Subject: Facility Response to Request for Additional Information (Acc. # ML16189A194)

On August 11, 2016, the NRC sent a Request for Additional Information (RAI) to Kansas State University nuclear reactor facility (license R-88, docket 50-188) regarding a license amendment request originally submitted on April 9, 2012 (Acc. # ML12109A063).

The following constitutes the facility's response to the RAI, and is organized as a numbered list of questions in the order of appearance in the RAI, followed by a response.

Figure 1 - Photo of reflector / grid plate assembly from GA-3399, showing space between grid plate and reflector.

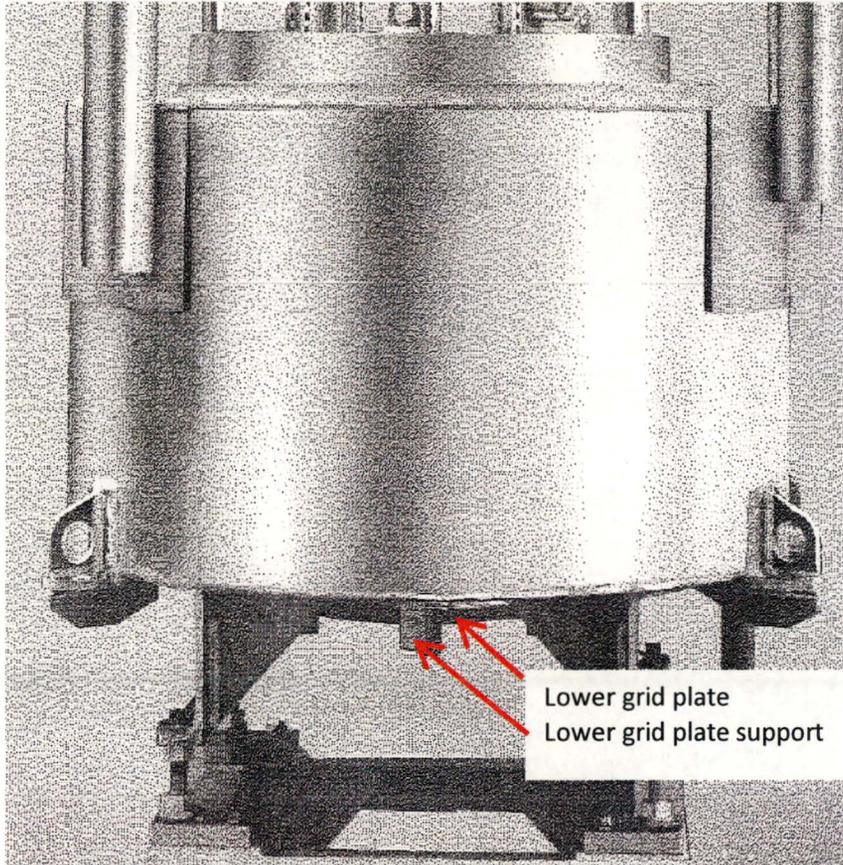
1. *SAR Section 4.2.5, "Core Support Structures," states "The bottom grid plate, which supports the weight of the fuel elements, has holes for receiving the lower end fixtures. Space is provided for the passage of cooling water around the sides of the bottom grid plate and through 36 experiment penetrations. The 1.5 in. (3.8 cm) diameter holes in the upper grid plate serve to space the fuel elements and to allow withdrawal of the elements from the core. Triangular-shaped spacers on the upper end fixtures allow the cooling water to pass through the upper grid plate when the fuel elements are in position. The reflector assembly supports both grid plates. Provide the drawings of the core support and other structures. Also provide documentation describing the flow path geometry around the side of the bottom grid plate.*

2. The description of the flow geometry in the license amendment request is primarily based on the mechanical maintenance manual, GA-3399, "250-kW TRIGA Mark II Pulsing Reactor Mechanical Maintenance and Operating Manual." The corresponding section from the manual is attached as Attachment 1. The flow path geometry between the bottom grid plate and the reflector is almost totally unobstructed by structural components. The bottom grid plate is held by small L-shaped brackets. These are shown in an un-numbered shop sketch, attached as Attachment 2. This sketch also specifies that the reflector aluminum is 3/8" thick. Figure 1 is a photo from GA-3399 which depicts the gap between the lower grid plate and reflector.

Figure 2 - ANSYS model of coolant pressure drop for TRIGA reactor operating at 1250 kW.

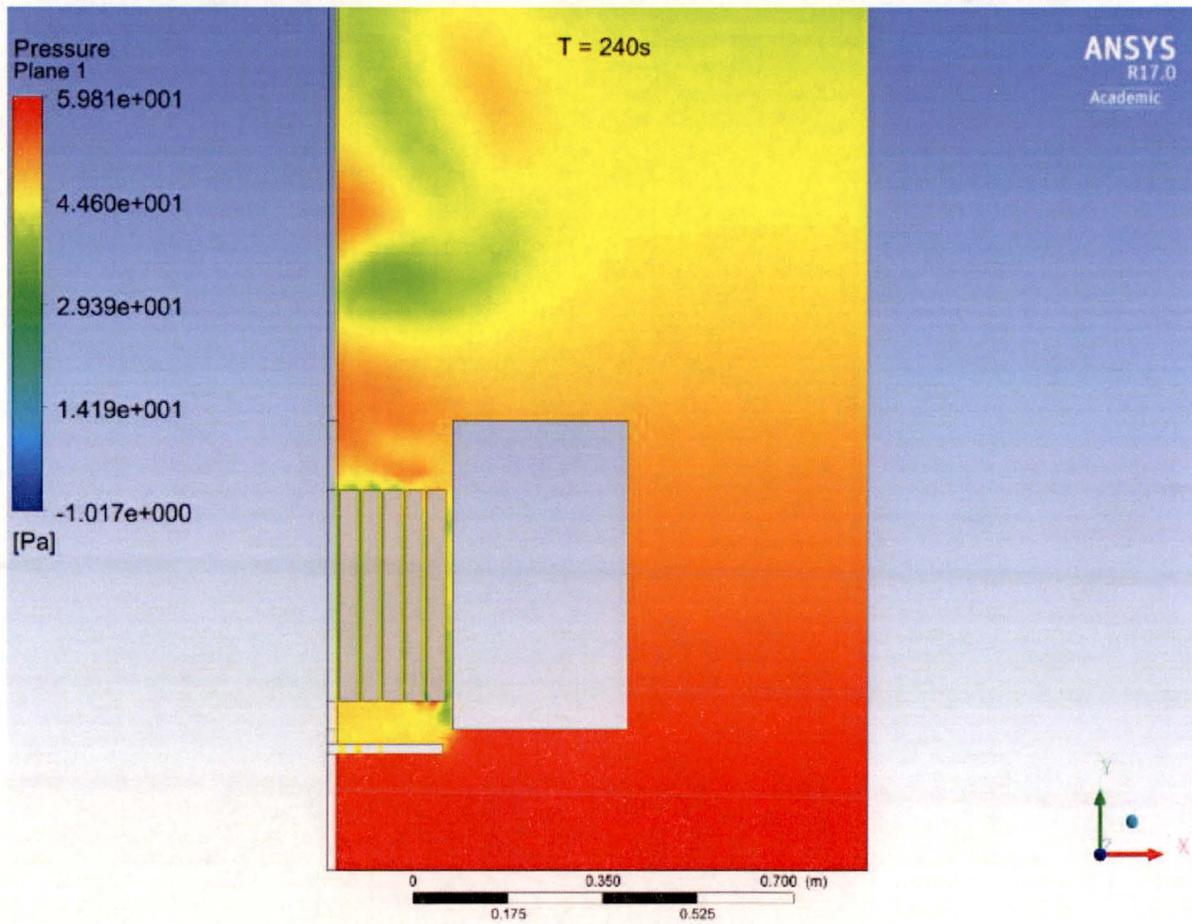
3. The loss coefficient for the core exit is calculated on page 4-26 of the SAR to be 0.171. It is described as a contraction loss. The actual flow will undergo a contraction followed by an expansion when flowing through the grid plate. Provide the basis for the formula used to calculate the core exit loss coefficient.

The exit pressure loss,  $\Delta P_e = \frac{K_e \rho v_e^2}{2}$ , is based on the downstream flow velocity ( $v_e$ ). Since the velocity of the coolant exiting the core is very low, this expansion loss was ignored. Supporting calculations were performed using a TRIGA core model in ANSYS, for an operating power level of 1250 kW. These calculations show (see Fig. 2) that the pressure drop for coolant leaving the core of  $\sim 20$  Pa, i.e., much less than one atmosphere.

Figure 3- Axial temperature profile of reactor coolant in B-ring using RELAP calculations

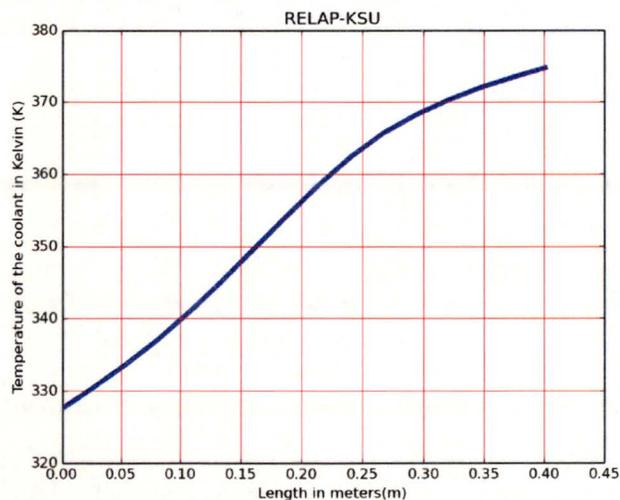
5. According to SAR Section 4.6, the calculation for core flow rate vs. power uses a core inlet temperature of 27 degrees Celsius and uses an equation that is applicable only to single phase flow. Are the pool temperature limits designed to ensure that single phase flow exists across the core?

The coolant temperature limits are designed to prevent damage to the ion exchange resin used to maintain low primary water conductivity, not to ensure single phase flow. GA TRD 070.01006.04, "TRIGA Reactor Thermal-Hydraulic Design Study" (2008) contained a RELAP and STAT and concluded that the three 1 MW TRIGA cores analyzed in the study would not experience nucleate boiling at their design temperatures, and the void fraction at a 2 MW TRIGA considered in the study would be 1.5% for an 86°F inlet temperature. This inlet temperature is slightly higher than the 27°C temperature used in the KSU SAR, but is below the 130°F KSU Tech Spec limit on water temperature (130°F = 54.4°C). Calculations performed at KSU in support of this RAI response indicate that the reactor would reach nucleate boiling at 1250 kW for the power peaking assumed in the SAR (2.0), but would have several degrees of margin to nucleate boiling at more realistic power peaking factors calculated with MCNP. MCNP calculations were used to obtain volumetric heat generation rate in the maximum power B-ring fuel rod. A validated RELAP model was modified with this input heat generation rate and KSU tech spec limit as inlet temperature. The calculations were used to evaluate axial profile of coolant temperature (shown in Fig. 3). The outlet temperature of coolant was computed to be 101°C. This is above the boiling point of water at standard temperature and pressure, but slightly below the boiling point of water at the core depth of ~5 meters below the surface of the water.

Figure 4 - ANSYS calculation of coolant flow velocity through the KSU TRIGA reactor core when operating at 1250 kW.

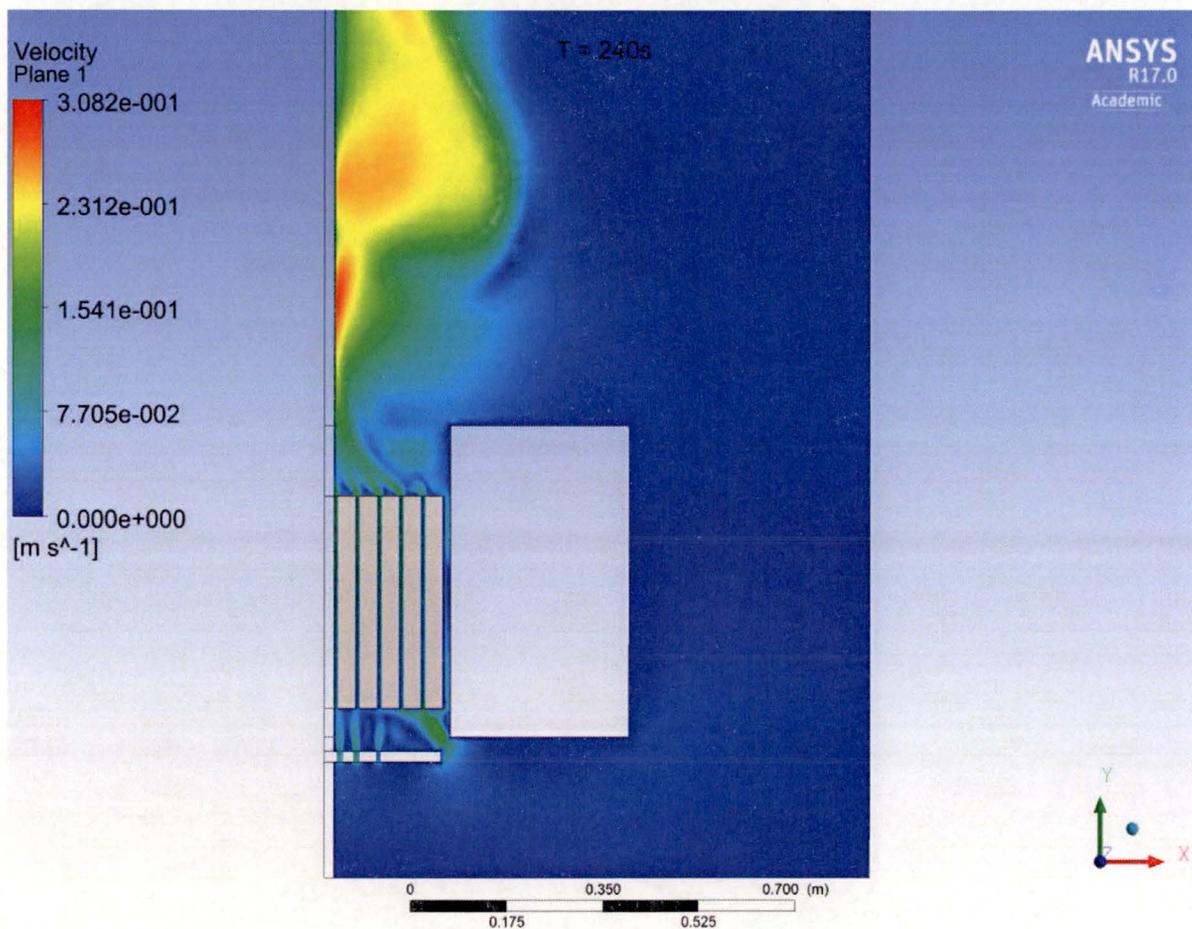
6. SAR Section 4.6 states that the entrance of coolant into the core is from the side, above the lower grid plate (see Section 4.2.5) and the entrance pressure loss would be expected to be negligible. There is no basis for this statement. Provide the basis.

As indicated by the ANSYS model shown in Figure 4, the pressure drop above the grid plate is on the order of 20 Pa. These calculations also indicate that the majority of the coolant flow into the core will be from the side, which is the path of least resistance for the coolant. (See Fig. 4). These results are consistent with the pressure loss model in SAR report which models the overall flow resistance to be harmonic mean of flow resistance across the grid plate and flow resistance across the side gap between grid plate and reflector. Due to larger opening size, flow resistance through the side gap is negligible and thus most of the coolant is expected to flow through the side.

Figure 5 - Effect of fuel radius adjustment on power peaking.

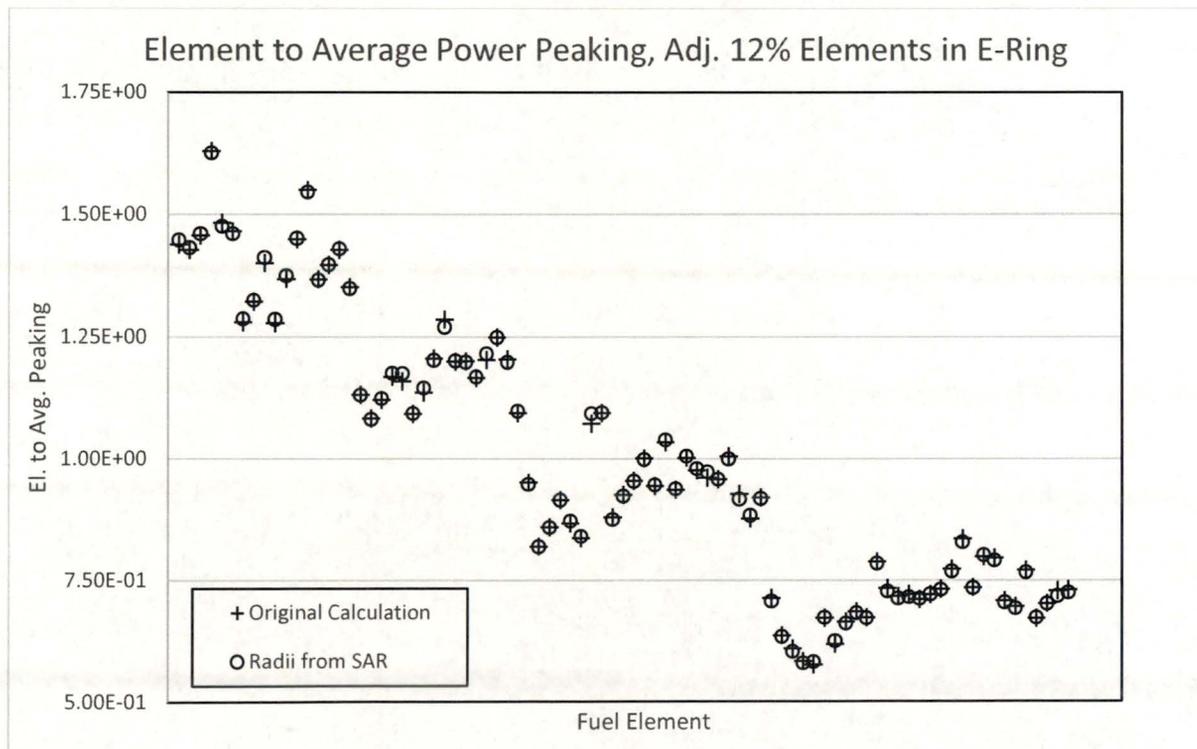
6. The NRC staff wants to reconcile the fuel pin cylindrical radii given in surfaces 200 through 202 with what they were able to calculate from the SAR and some of the cited reference that describe Mark III fuel. The NRC staff arrived that the following values for pin radii: middle zirconium rod (0.3175 cm); fuel-moderator material (1.8161 cm); gap (1.8415 cm); and clad (1.8669 cm). Supply the basis for the dimensions given in Surfaces 200 through 202.

No gap was modelled between the fuel meat and cladding; the void inside the fuel element was only modelled above the axial graphite reflector. The radii used in the model seem to be slightly off from the values in the SAR and other references. In order to verify that this did not significantly impact the safety basis for the addition of new fuel, one of the modeled cases was repeated with the fuel meat and cladding radii adjusted to exactly match the values in SAR Table 13.1, fuel radius = 1.8161 cm and clad outside radius = 1.8669 cm. The case that was re-modeled featured two adjacent 12%-loaded elements in the E-ring. As a result of this adjustment, the element to average power peaking changed minimally, with the greatest increase in calculated power peaking being an increase of +1.9% for element E-7 (one of the 12%-loaded elements). As can be seen from the results, the change in calculated power peaking that results from correcting the fuel feature radii is minimal and does affect the determination that 12%-loaded elements in the E- and F-ring will have a much lower power peaking and fission product density than 8.5%-loaded elements in the B-ring. The adjustments that were made to the fuel radii in the model were also incorporated into further revisions to the model that were made to address later questions in the RAI.

Figure 6 - Updated power peaking calculation from MCNP, based on F7 tally.

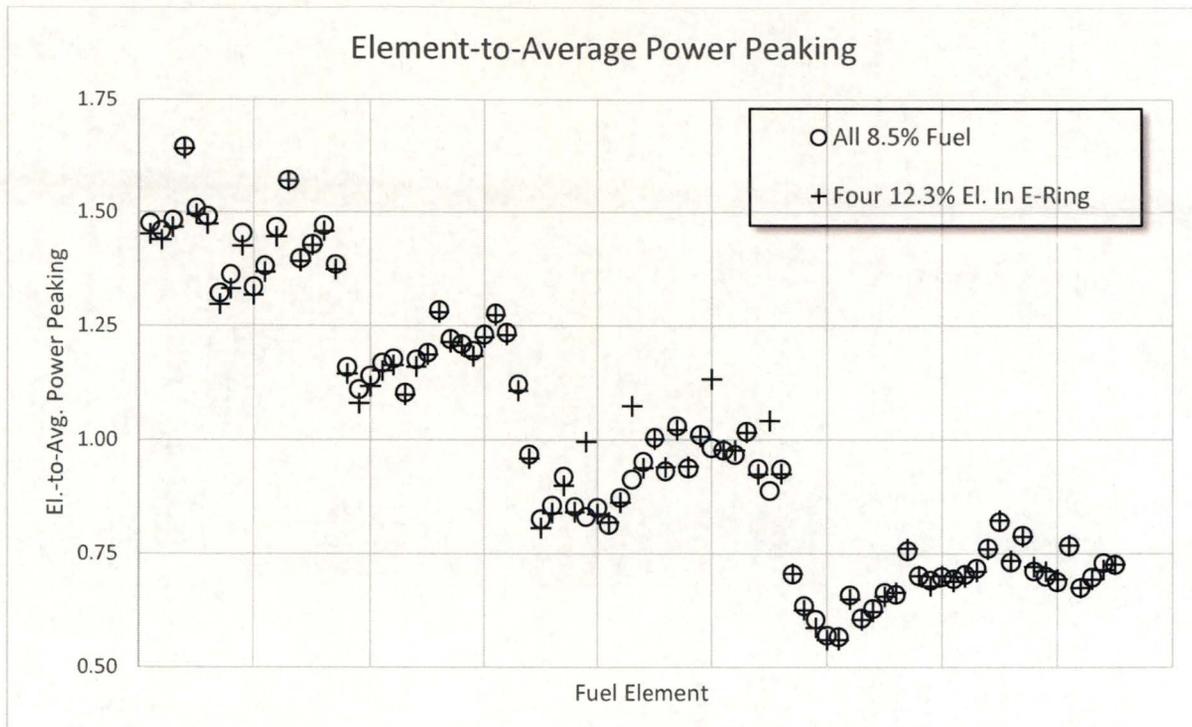
10. In RAI No. 1 of the KSU RAI response, KSU gives a methodology for determining the change in Uranium-235 mass with burnup (initial fuel composition minus the burnup per element). Provide the composition of the maximum burnup element that is calculated through this methodology.

The maximum element-to-average power peaking due to the addition of four 12% elements in the E-ring was found to change as follows. Note that the four elements were placed in the same E-ring locations as in the original LAR-supporting calculations. These results are compared to the 12.3%-load case from the original work, since the 12% elements in the revised model were given a loading corresponding to the maximum load of 12% fuel on hand at KSU, which is approximately 12.3% uranium by weight. The reactivity effect of adding the 12% fuel is calculated to be higher based on the revised model; however, the calculation does not show that the minimum safety shutdown margin, which at present is approximately \$2.60, will be challenged.

Figure 6 shows the power peaking for the updated MCNP model, with all 8.5%-loaded fuel (i.e., current license) versus a core with four 12.3% elements in the E-ring.
